AGENDA

Planning Committee Meeting to be held
at Darebin Civic Centre,
350 High Street Preston
on Monday, 14 May 2018
at 6.00pm.

5.1 APPLICATION FOR PLANNING PERMIT 386-392 Bell Street Preston

DRAWING NUMBER
A000 - TP4

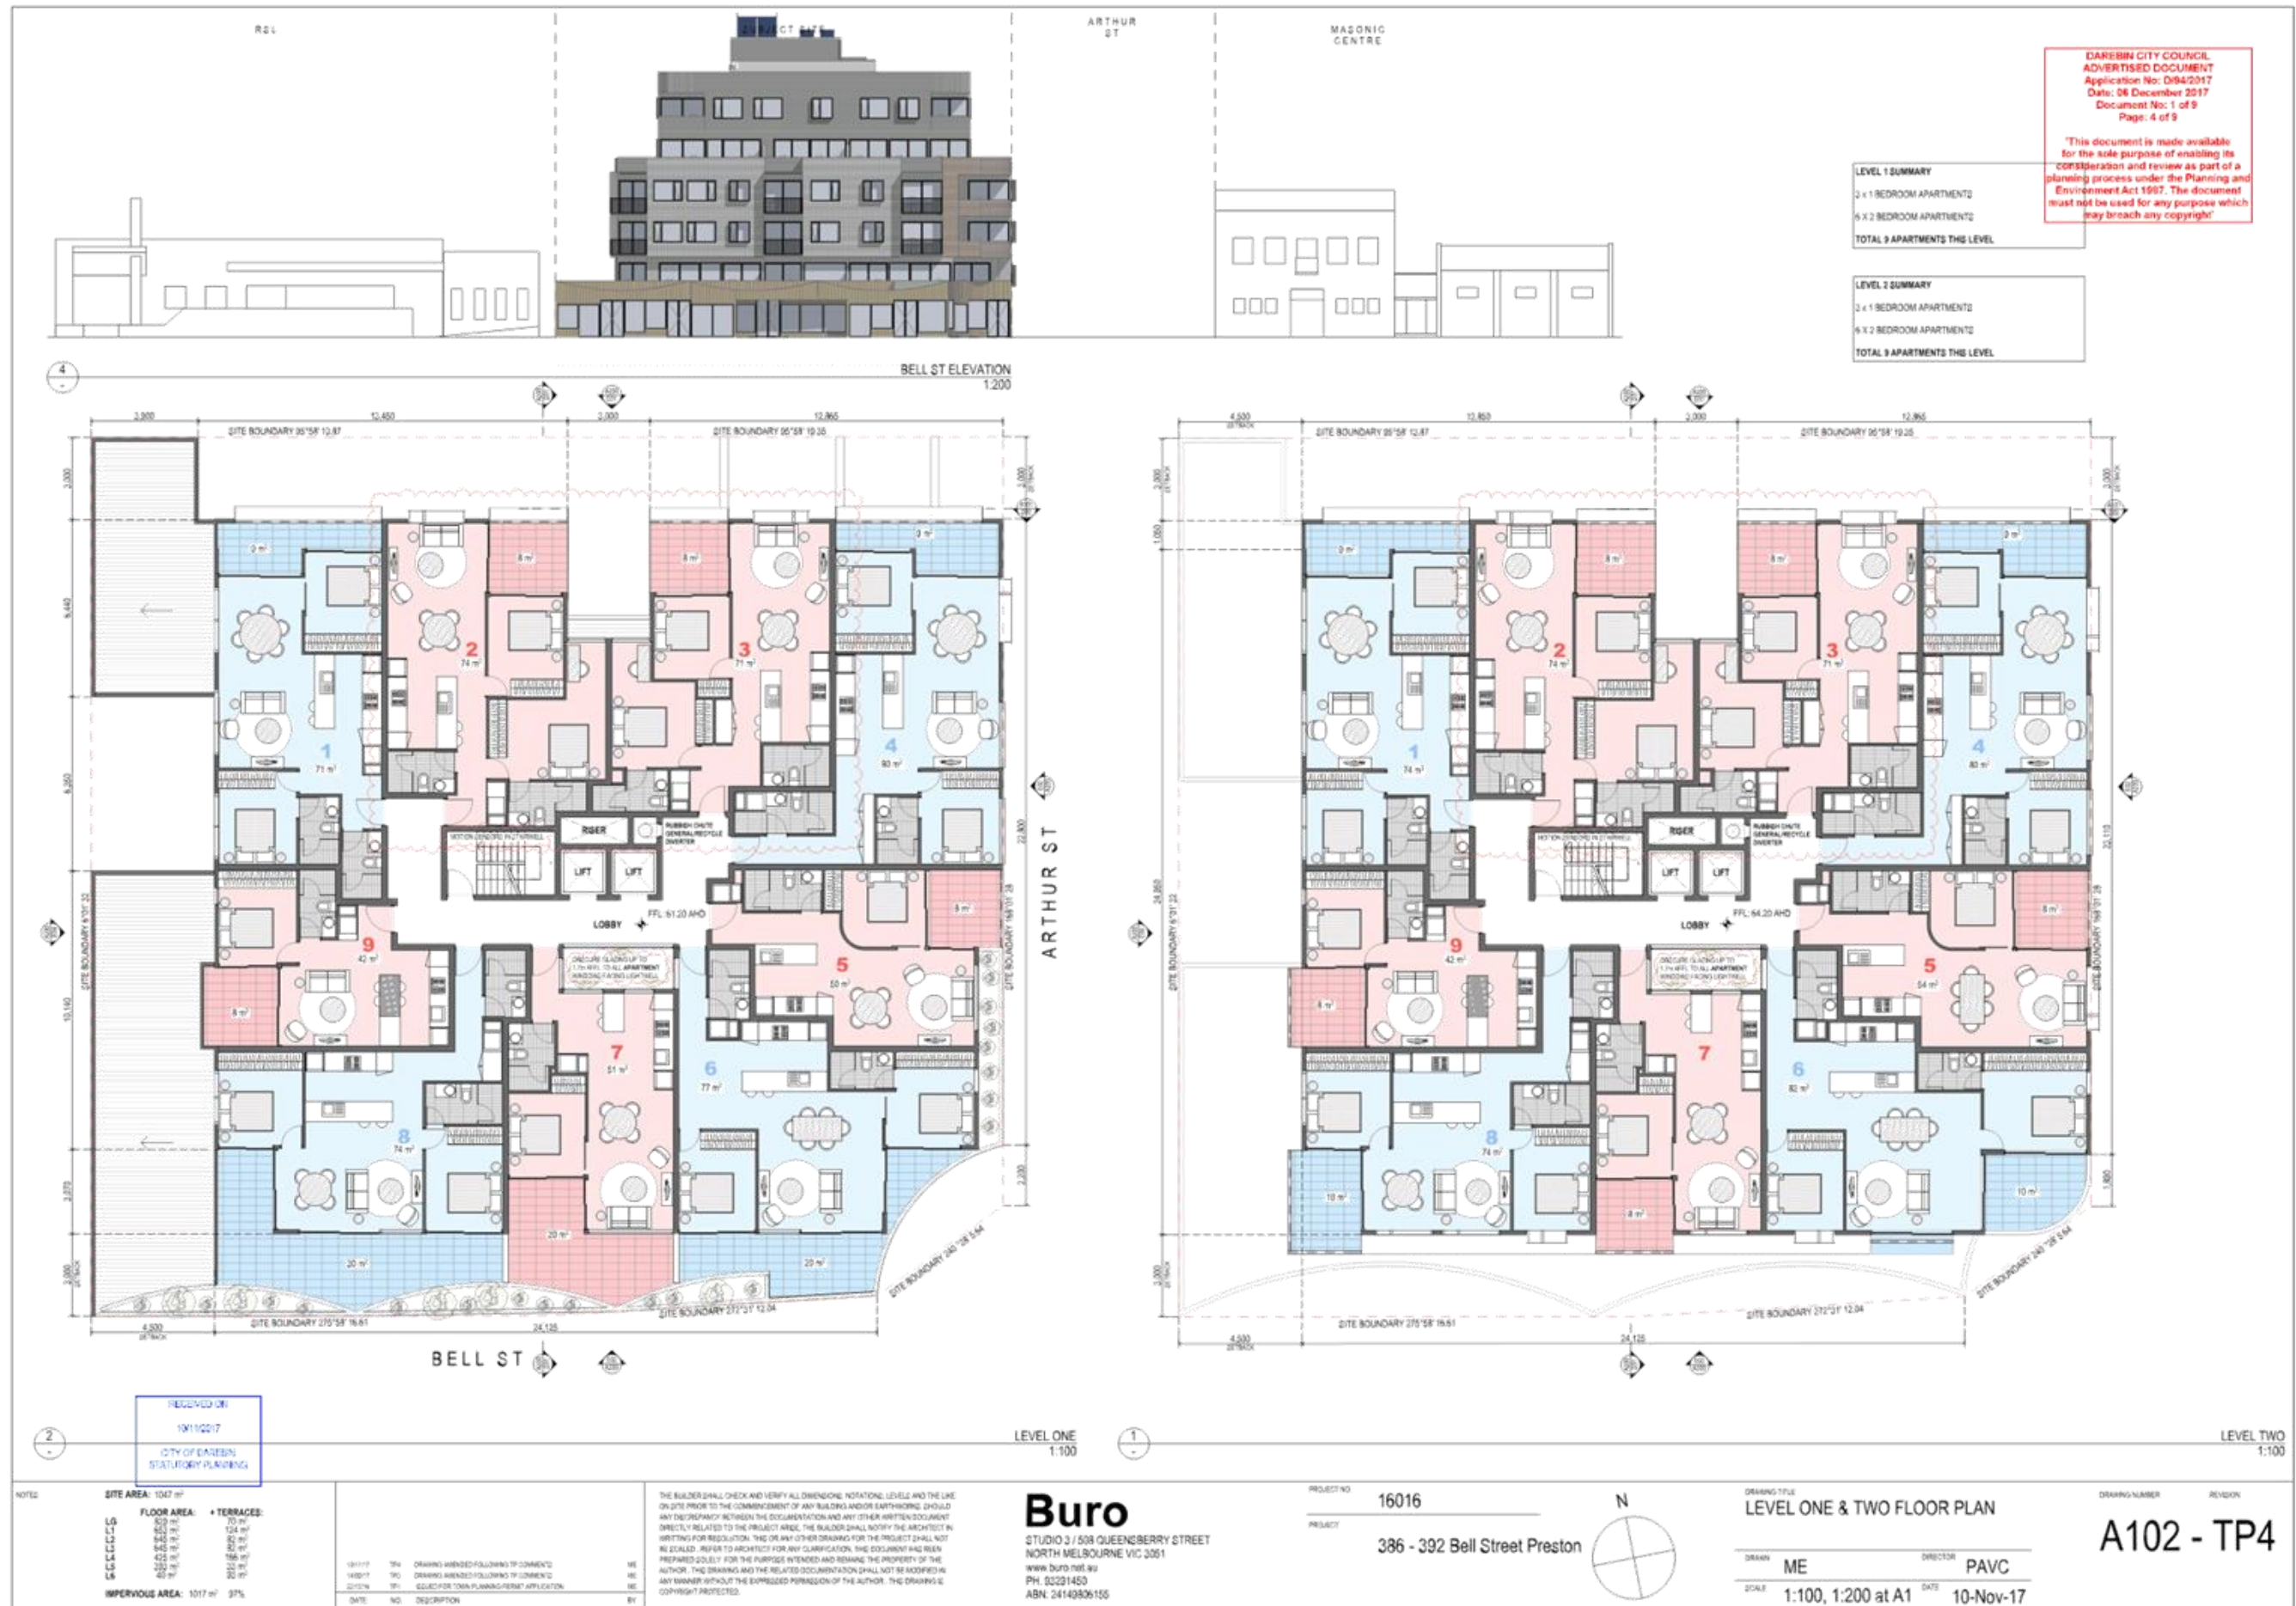
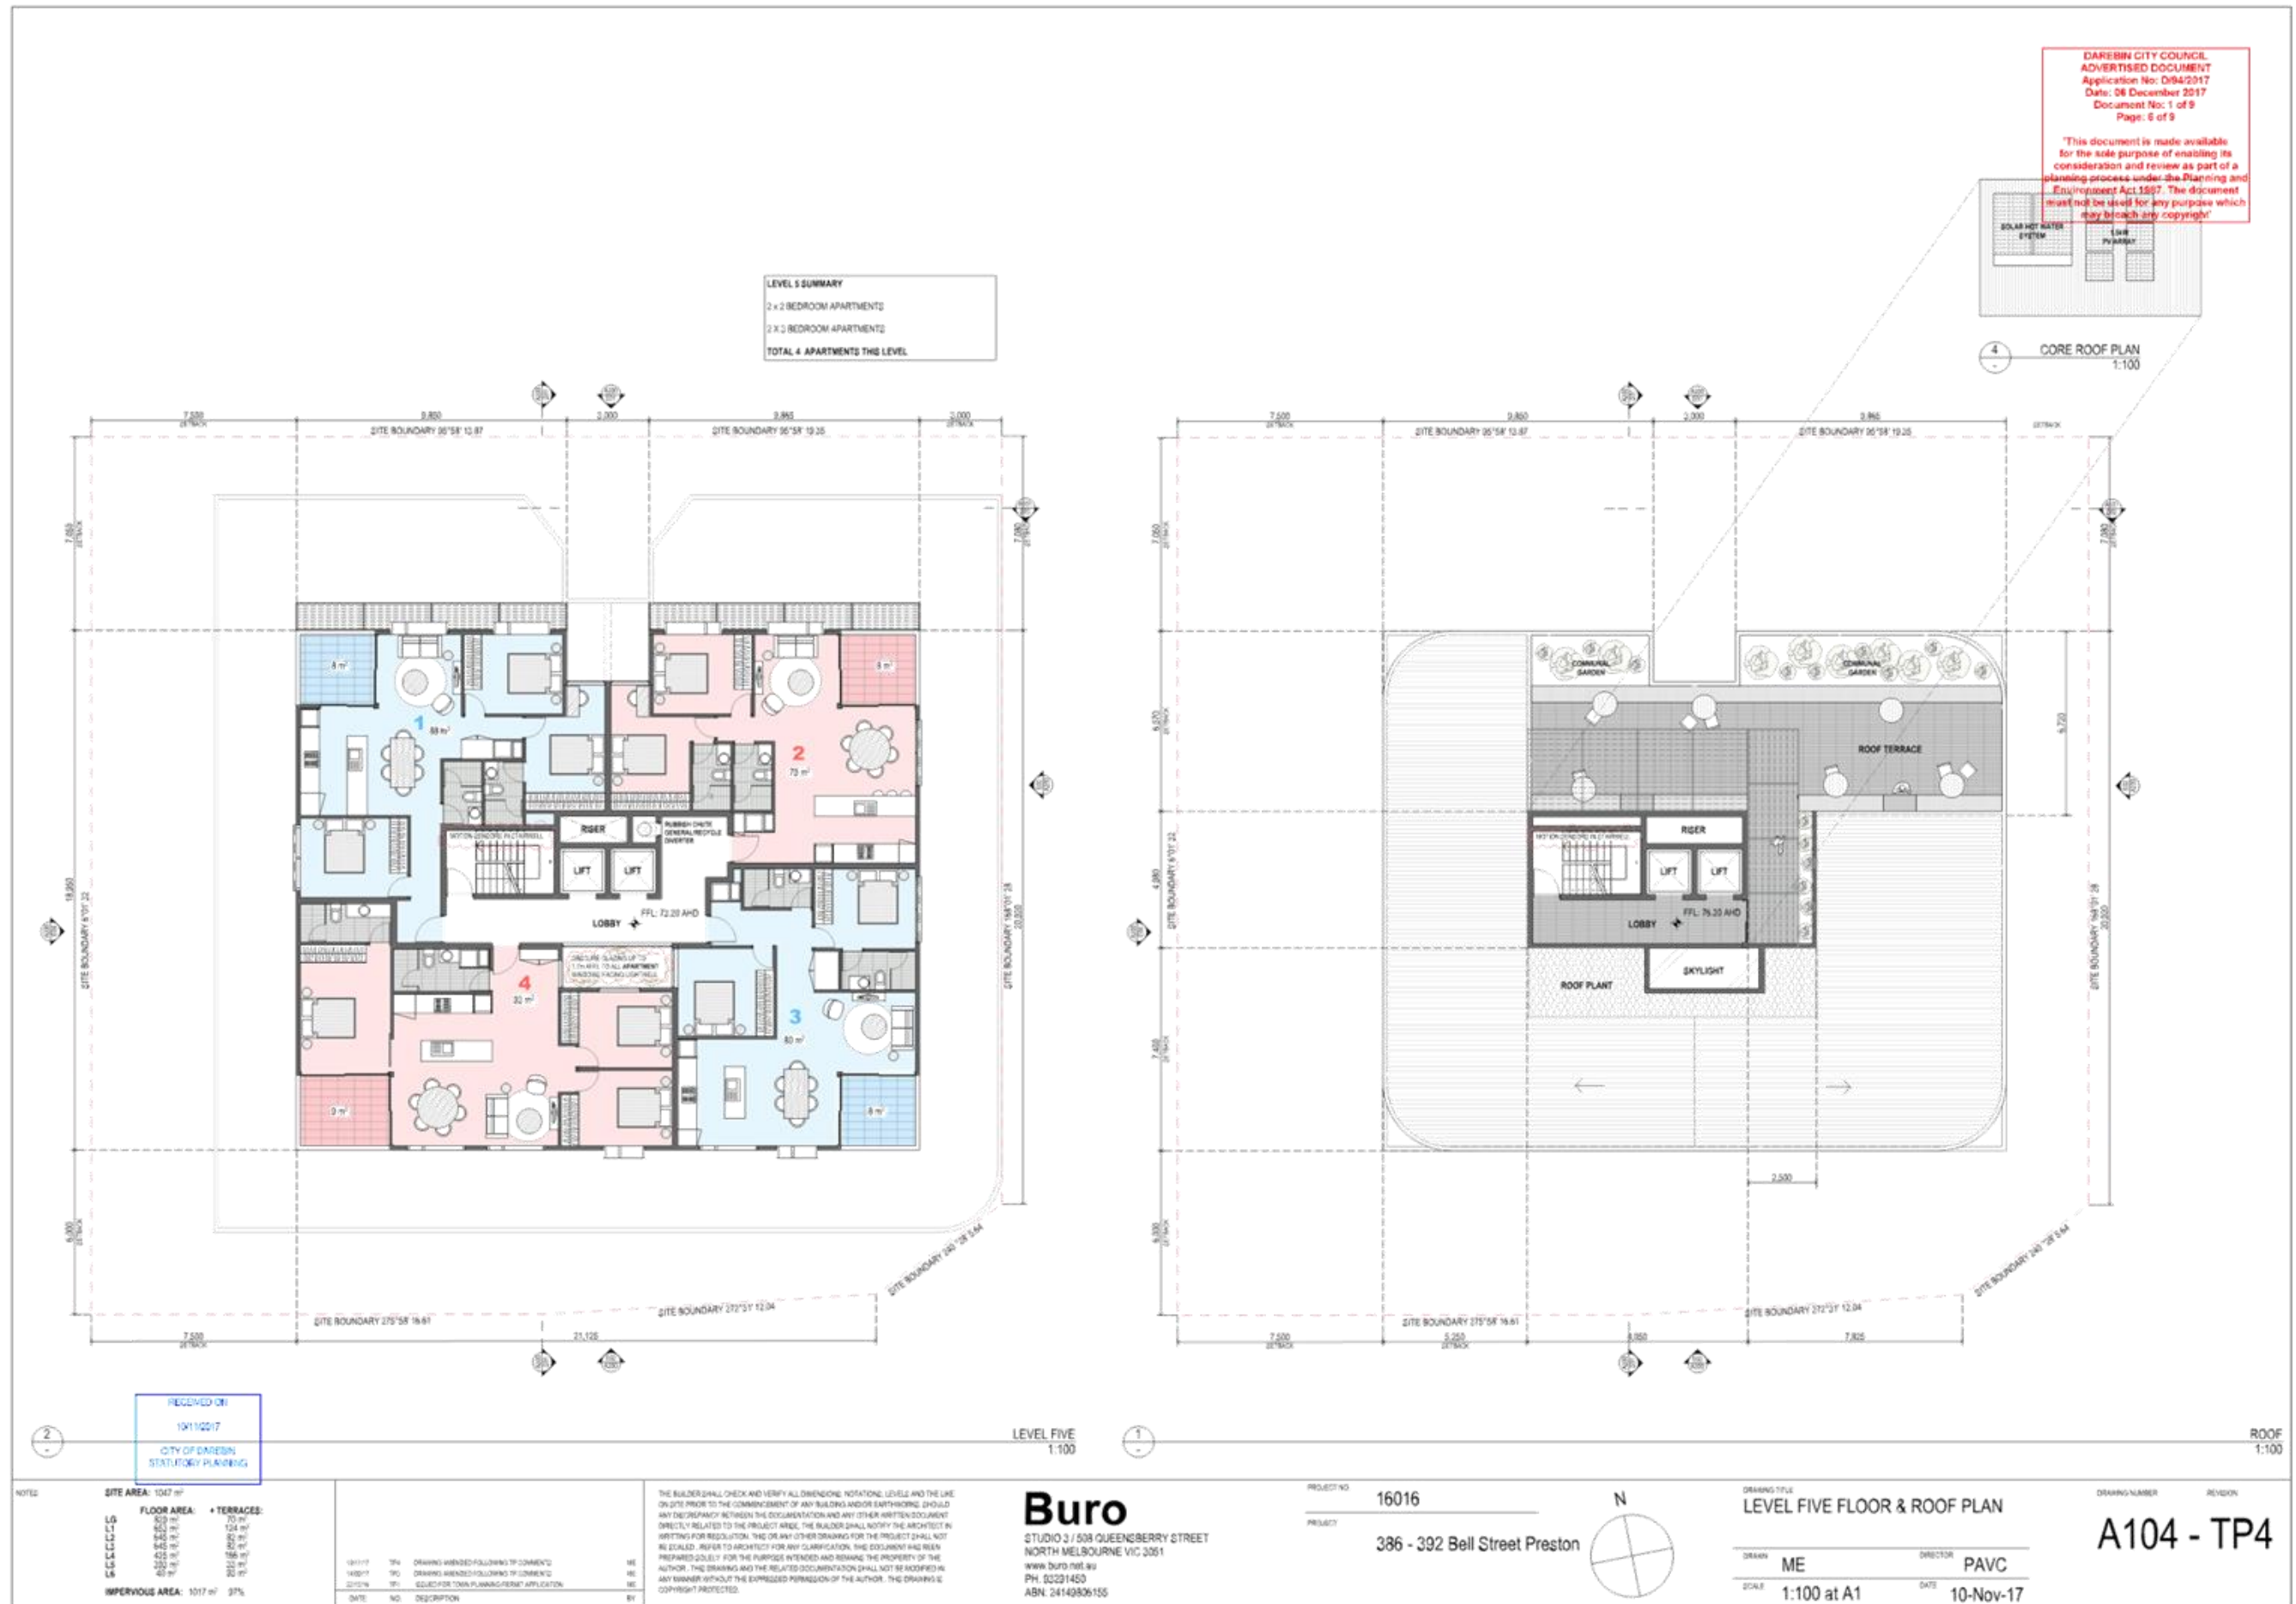
1. Before the development starts, amended plans to the satisfaction of the Responsible Authority must be submitted to, and approved by, the Responsible Authority. The plans must be drawn to scale with dimensions and must be generally in accordance with the plans submitted with the application (identified as drawings A101 – TP5, A102 – TP4, A103 – TP4, A104 – TP4, A200 – TP4 and A300 – TP4 dated November 2017 and prepared by Buro Architects) but modified to show:

- c) All bicycle parking spaces dimensioned in accordance with Australian Standard 2890.3:2015.
 - d) The length of the 1:8 transition increased to 2.6 metres at the ramp grade change from 1:4 to flat or a ground clearance assessment to the satisfaction of the responsible authority.

- e) The proposed Car Stacker Systems (Wohr Parklift 450-170 (320) and Wohr Parklift 450-200 (350)) clearly nominated.
 - f) Section plans updated indicating pit depths corresponding to the nominated car stacker system.
